Federal Register

[Docket No. FAA-2016-4228; Directorate Identifier 2015-NM-107-AD]

Airworthiness Directives; Airbus Airplanes

ACTION: Notice of proposed rulemaking (NPRM).

Figure 1 to paragraph (i)(7) of this AD – Design A of the Passenger Oxygen Containers Affected by this AD

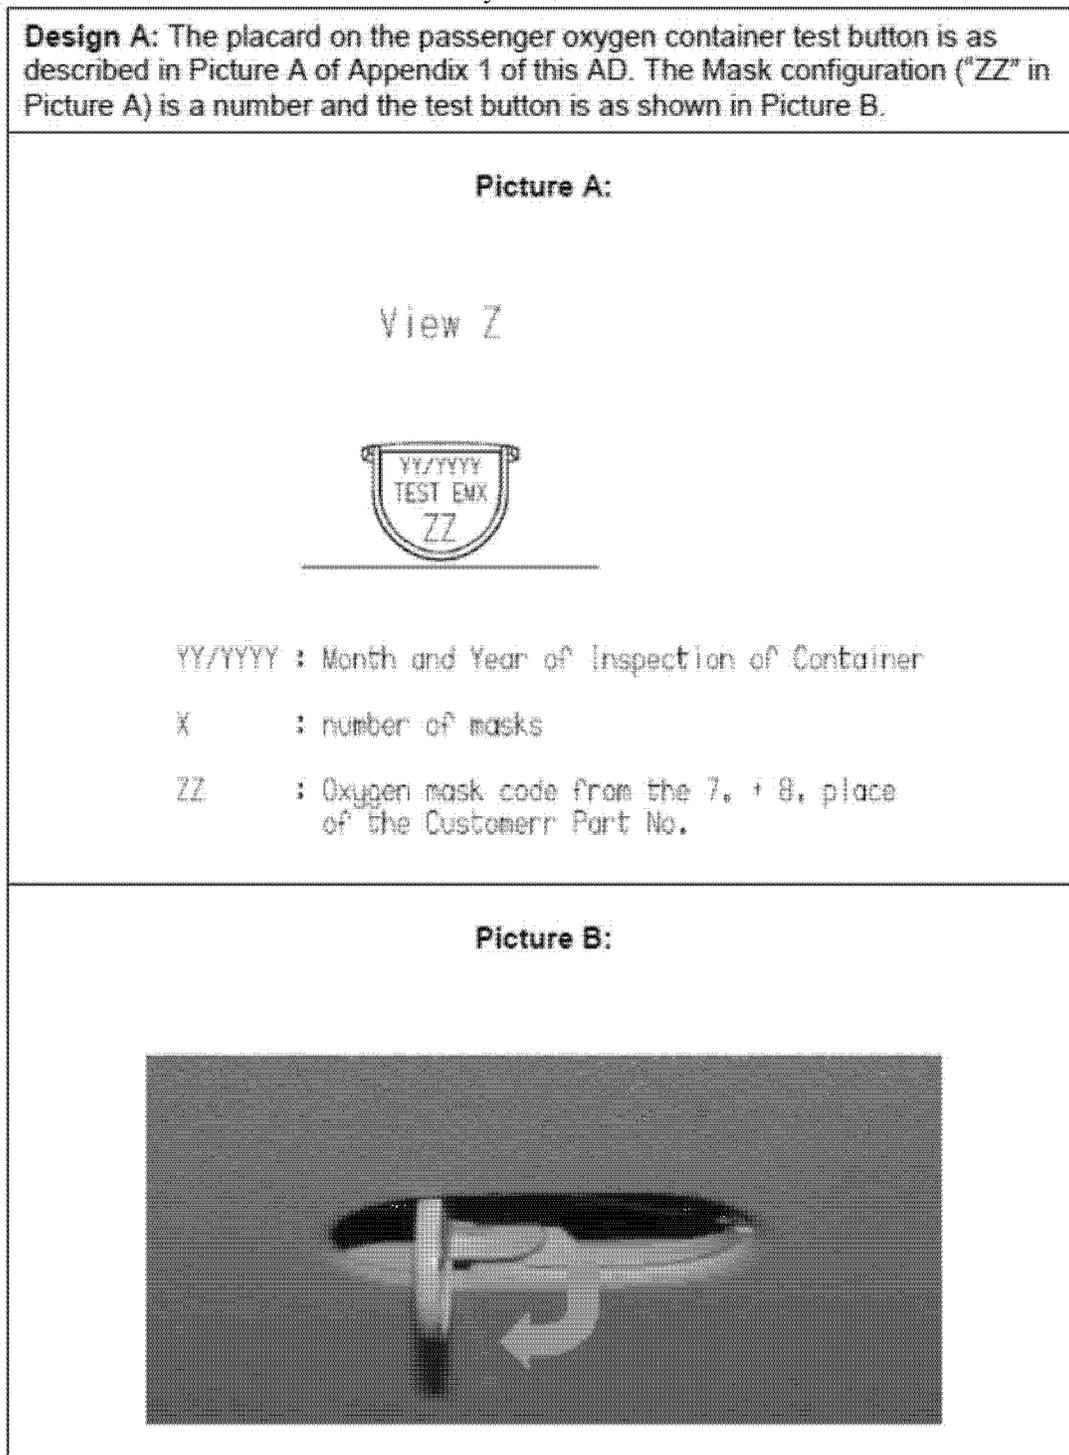
We have added Note 2 to figure 1 to paragraph (i)(7) of this AD, which provides information to clarify information presented in figure 1 to paragraph (i)(7) of this AD.

(7) The requirements of paragraphs (g) and (h) of this AD apply only to passenger oxygen containers that are Design A, as defined in figure 1 to paragraph (i)(7) of this AD.

Note 2 to figure 1 to paragraph (i)(7) of this AD: For “Design A,” the placard on the passenger oxygen container test button is as

described in “Picture A” in figure 1 to paragraph (i)(7) of this AD. The mask configuration (“ZZ” in “Picture A”) is a number, and the test button is as shown in “Picture B.”
